ADDENDUM NO. 1

TO: ALL BIDDERS
PROJECT: ITB PW 37-19 – FOY SHAW PARKWAY
BID TIME AND DATE: 3:00 PM LOCAL TIME, September 04, 2019 (NO CHANGE)

August 22, 2019

FOY SHAW PARKWAY FROM US 90 TO JOHN GIVENS ROAD FINANCIAL PROJECT ID 425617-2-94-01

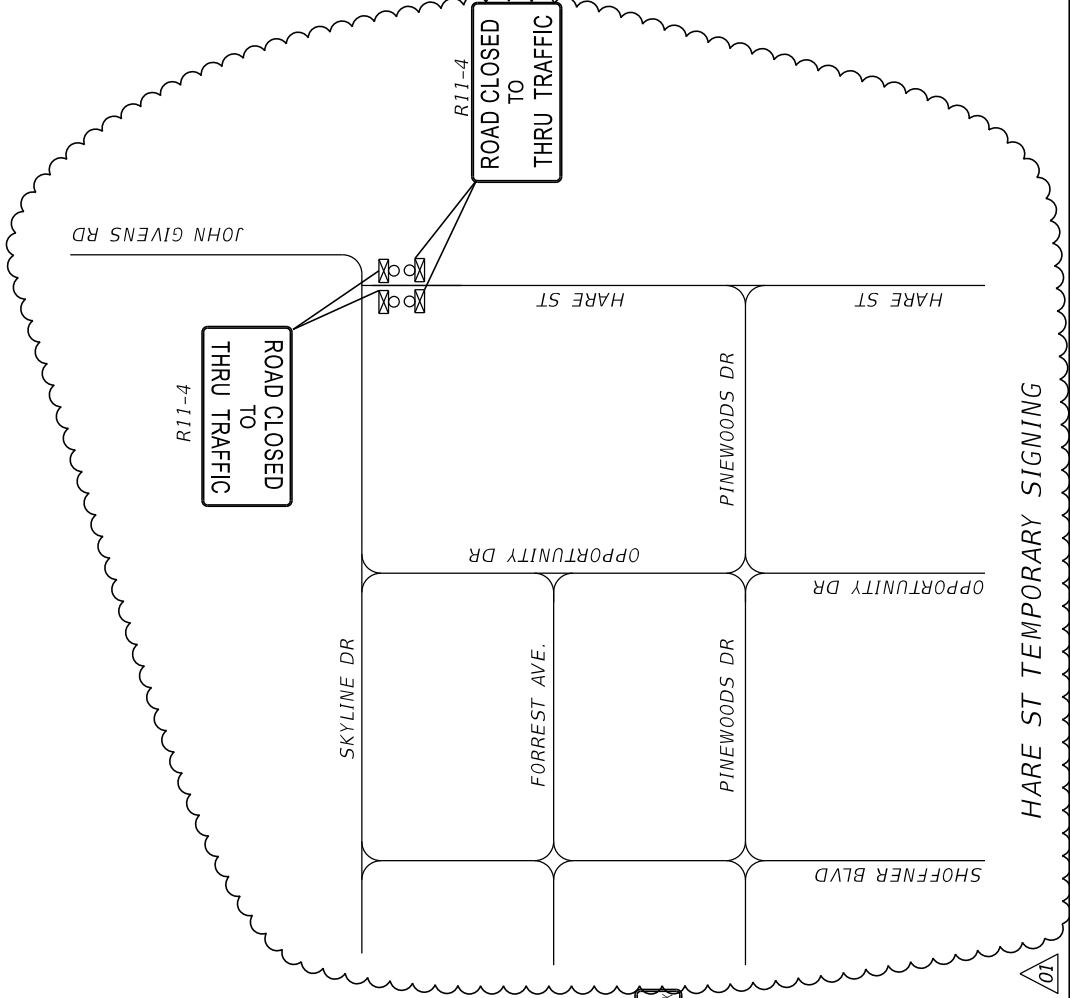
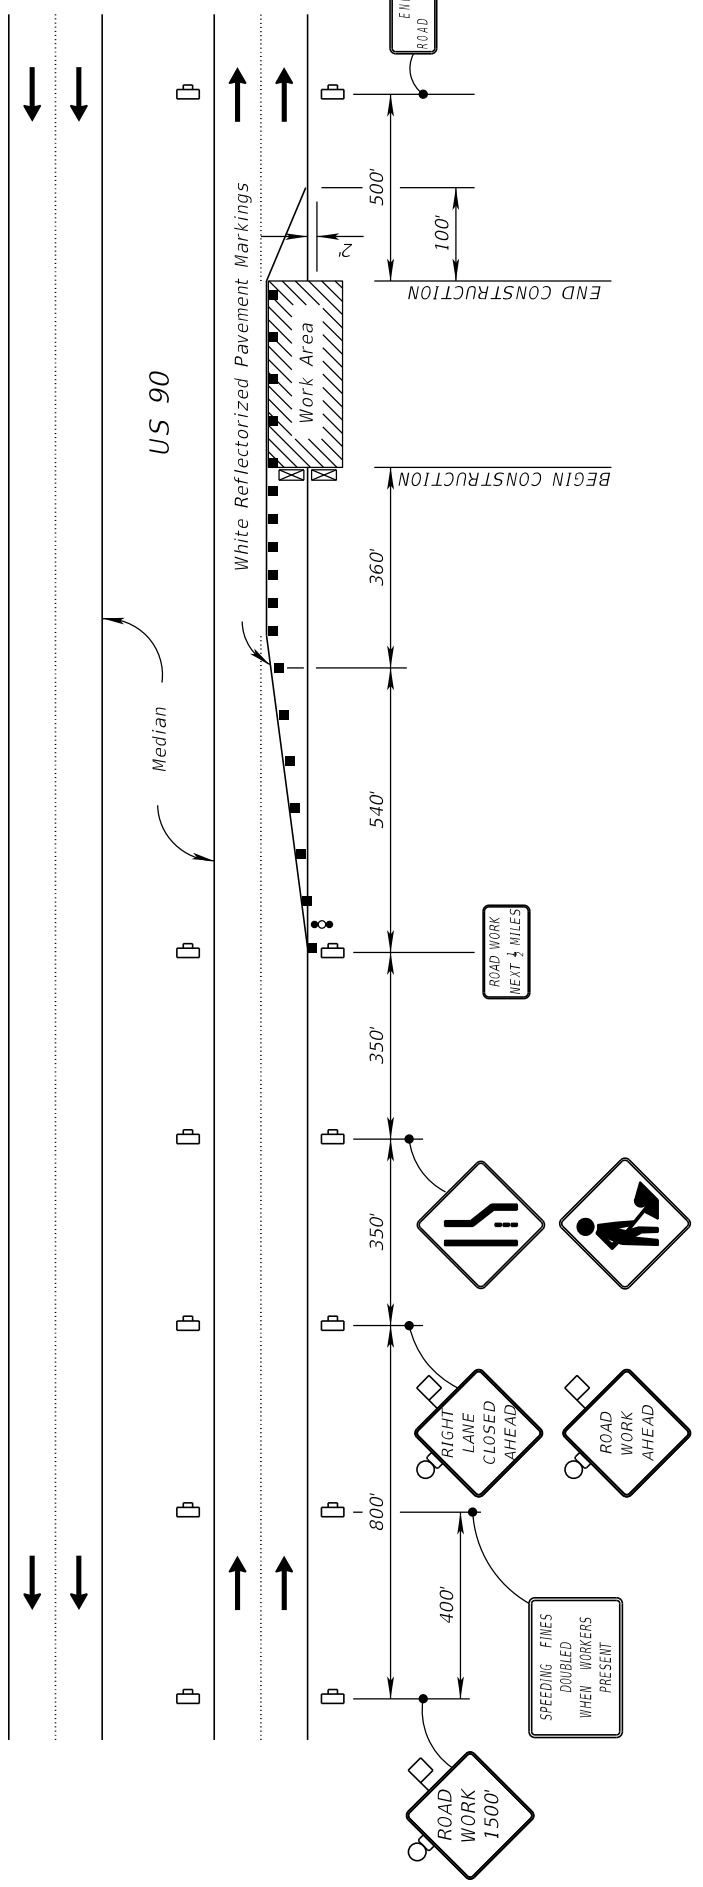
REVISIONS		OKALOOSA COUNTY		TRAFFIC CONTROL PLAN		SHEET NO.	
DATE	DESCRIPTION	DATE	DESCRIPTION	OKALOOSA COUNTY		NO.	
8/22/19	MOVED DETAIL TO THIS SHEET			OKALOOSA COUNTY		154	
	Addendum No. 1			OKALOOSA COUNTY			
				FPID: 425617-2-94-01			
				Jonathon D. Burchfield, P.E. P.E. LICENSE NUMBER 68451 HDR Engineering, Inc. 25 West Cedar Street, Suite 200 Pensacola, FL 32502-5945 CERTIFICATE OF AUTHORIZATION 4213

SHEET NO. 155

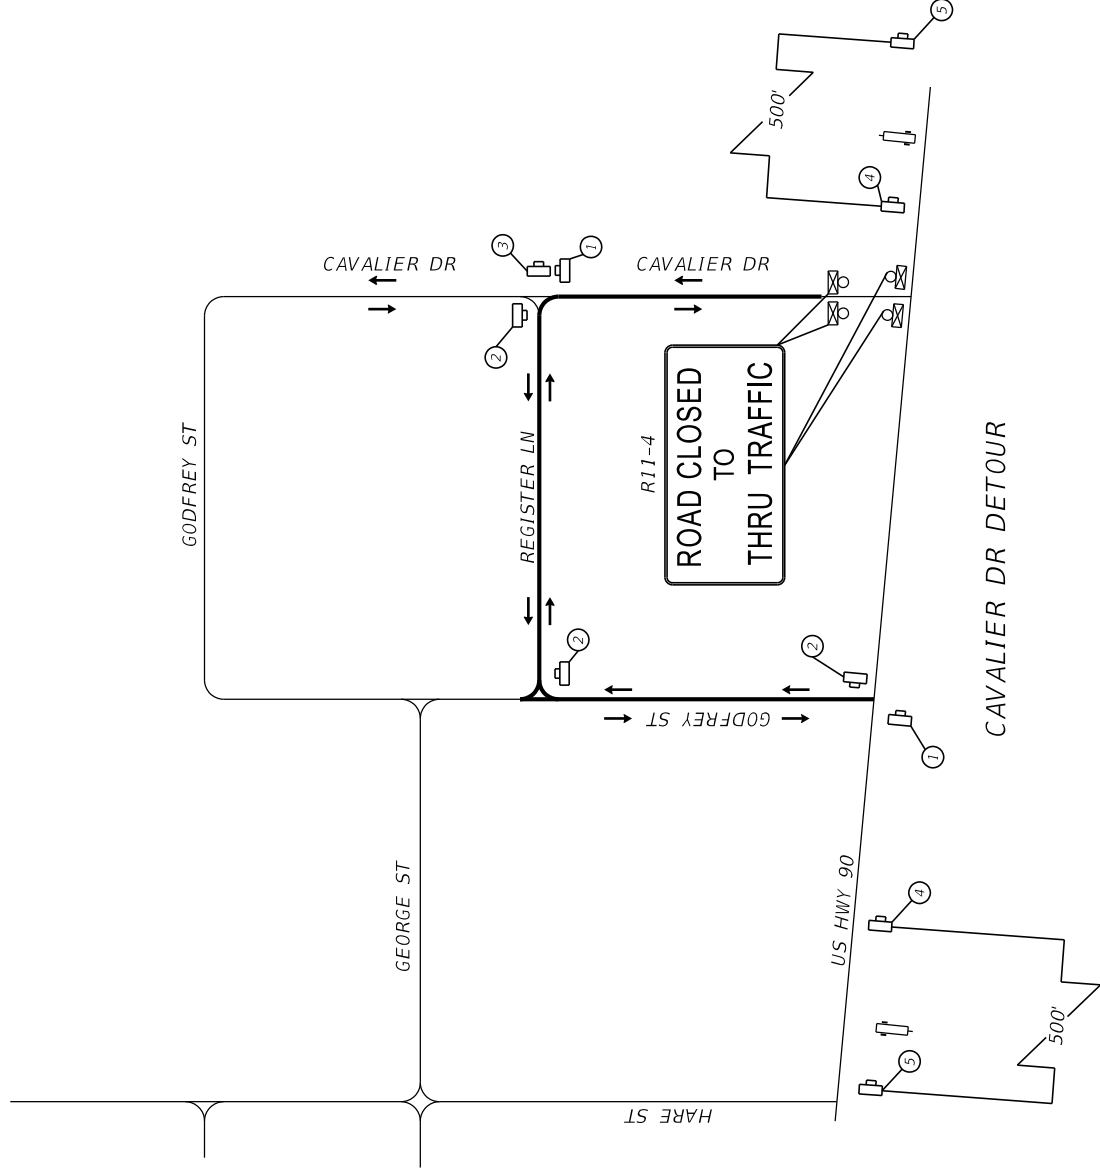
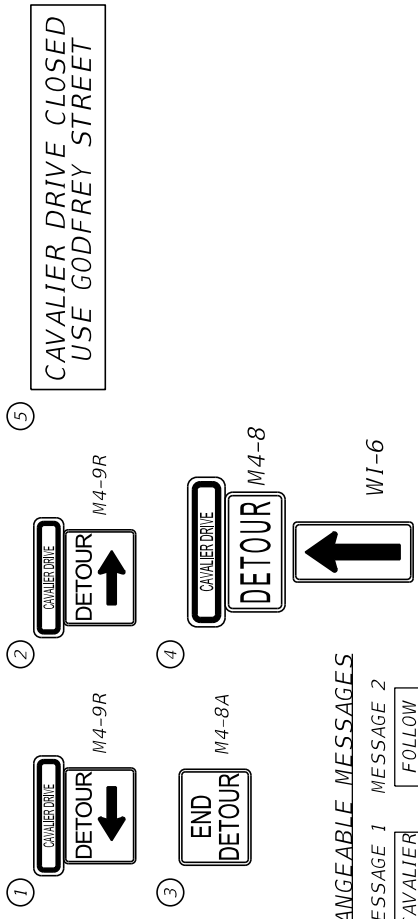
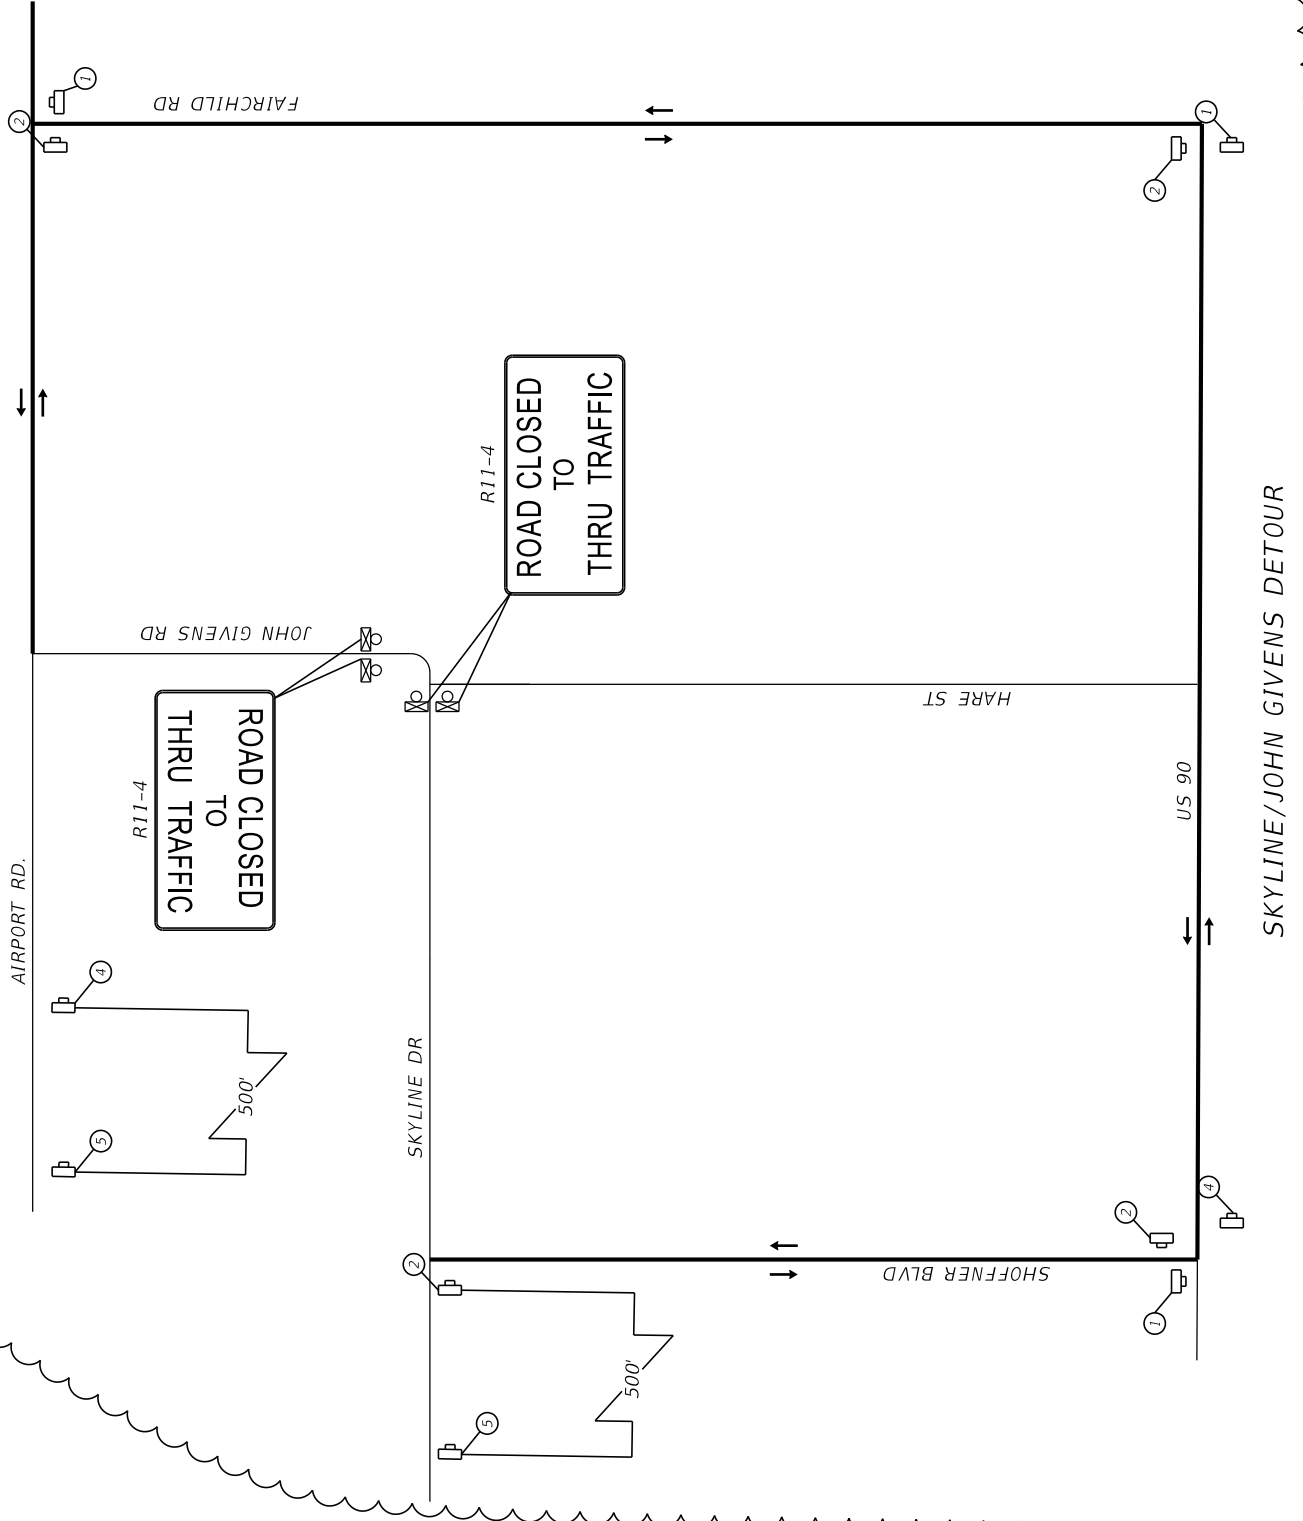
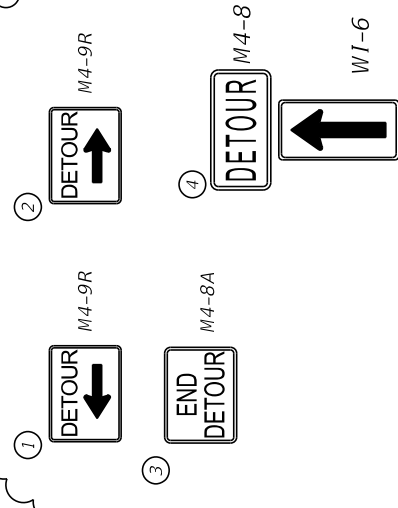
Question 2 – Sheet No. 155: What is the traffic control plan for Skyline Dr and John Givens Rd

DATE	DESCRIPTION	DATE	DESCRIPTION
8/22/19	ADDED SKYLINE/JOHN GIVENS DETOUR

Answer: The intent is to utilize a Detour along Fairchild Road and Airport Road during the construction of the Skyline Drive and John Givens Road intersection. This detail will be added to sheet 155.

NOTE: DETOURS ARE NOT TO BE UTILIZED AT THE SAME TIME
